## City of Ketchum

### **Recommendation to Hold a Public Hearing and Approve the 591 E. 9<sup>th</sup> Street (Hedgehog Subdivision) Lot Line Shift**

# A PRELIMINARY PLAT SHOWING HEDGEHOG SUBDIVISION

IN RE:	)	
	)	
Hedgehog LLS (591 E. 9 <sup>th</sup> )	)	KETCHUM CITY COUNCIL
Lot Line Shift	)	FINDINGS OF FACT, CONCLUSIONS OF LAW, AND
Date: September 8, 2020	)	DECISION
	)	
File Number: P20-072	)

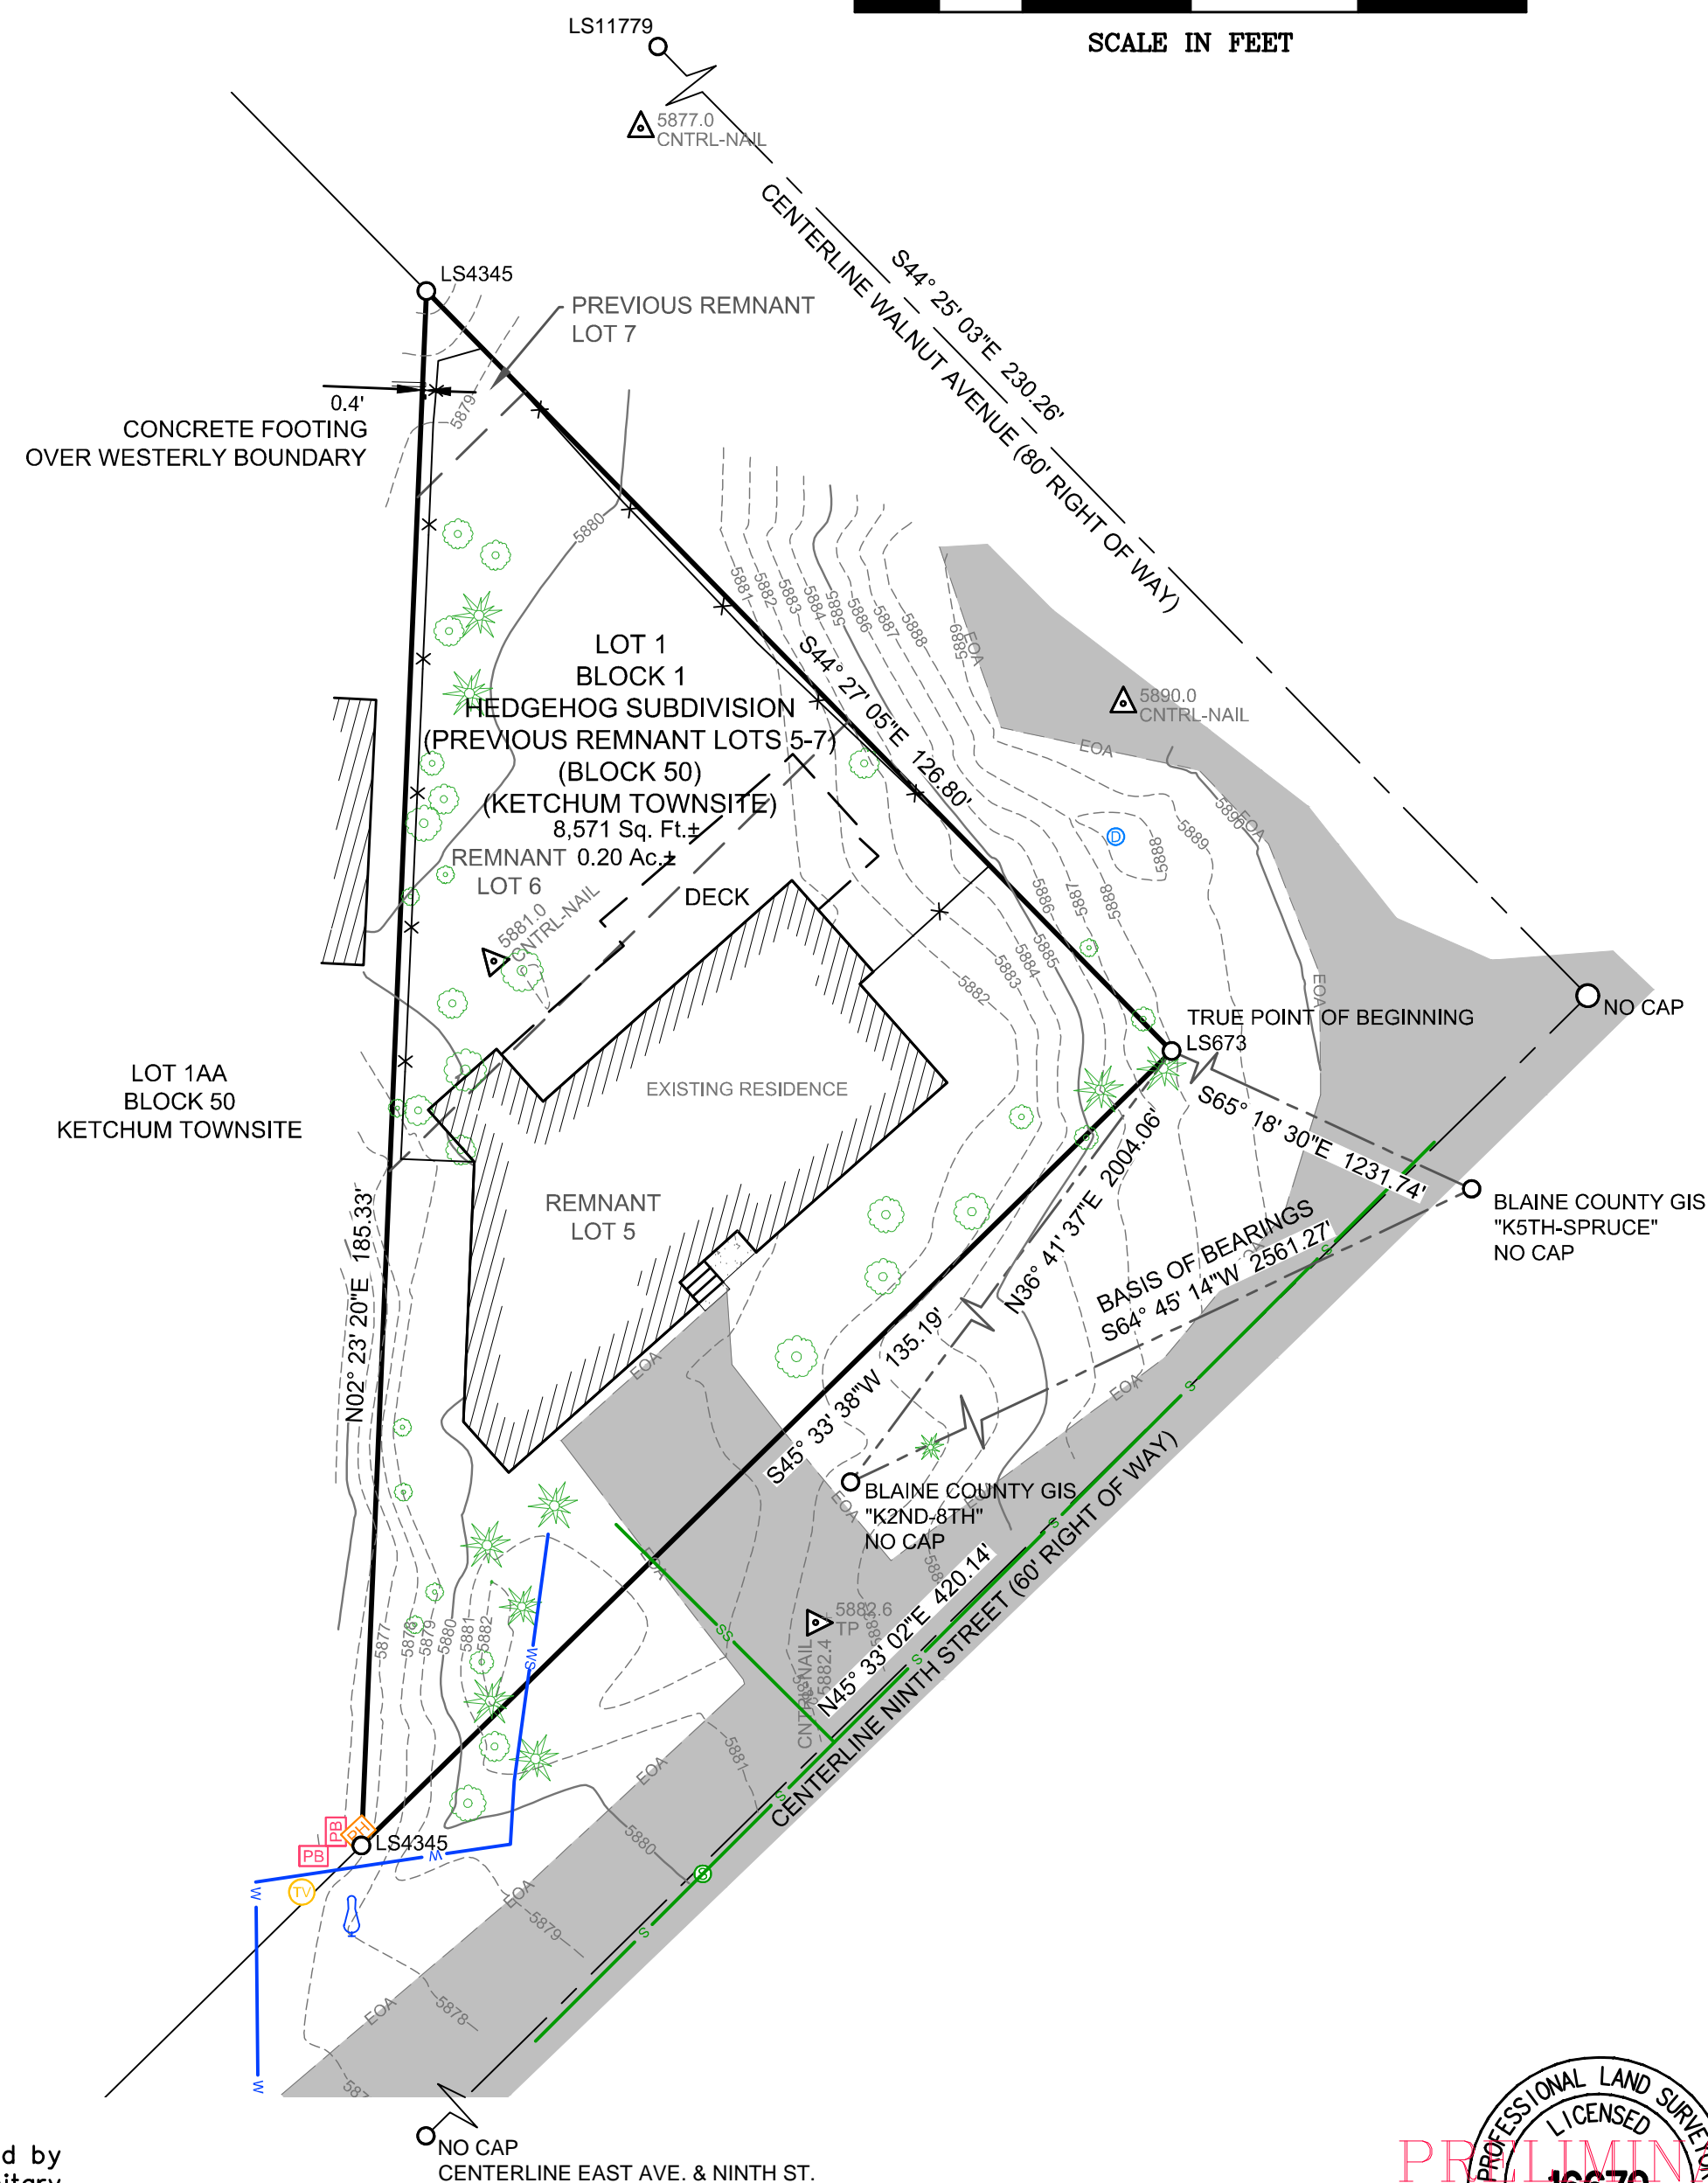
<b>Findings</b>	N/A. No street dedications are required or proposed.
X	<input type="checkbox"/>	<input type="checkbox"/>	<b>16.04.030.J .12</b>	<b>The location, size and type of sanitary and storm sewers, water mains, culverts and other surface or subsurface structures existing within or immediately adjacent to the proposed sanitary or storm sewers, water mains, and storage facilities, street improvements, street lighting, curbs, and gutters and all proposed utilities.</b>
			<b>Findings</b>	Existing drywells and sewer manholes in the ROW are indicated.
<input type="checkbox"/>	X	<input type="checkbox"/>	<b>16.04.030.J .13</b>	<b>The direction of drainage, flow and approximate grade of all streets.</b>
			<b>Findings</b>	Missing. Show direction of drainage, flow and approx. grade of Emerald and Topaz.

1. The recorded plat shall show a minimum of two Blaine County Survey Control Monuments with ties to the property and an inverse between the two monuments. The Survey Control Monuments shall be clearly identified on the face of the map.
2. An electronic CAD file shall be submitted to the City of Ketchum prior to final plat signature by the City Clerk. The electronic CAD file shall be submitted to the Blaine County Recorder’s office concurrent with the recording of the Plat containing the following minimum data:
  - a. Line work delineating all parcels and roadways on a CAD layer/level designated as “parcel”;
  - b. Line work delineating all roadway centerlines on a CAD layer/level designated as “road”; and,
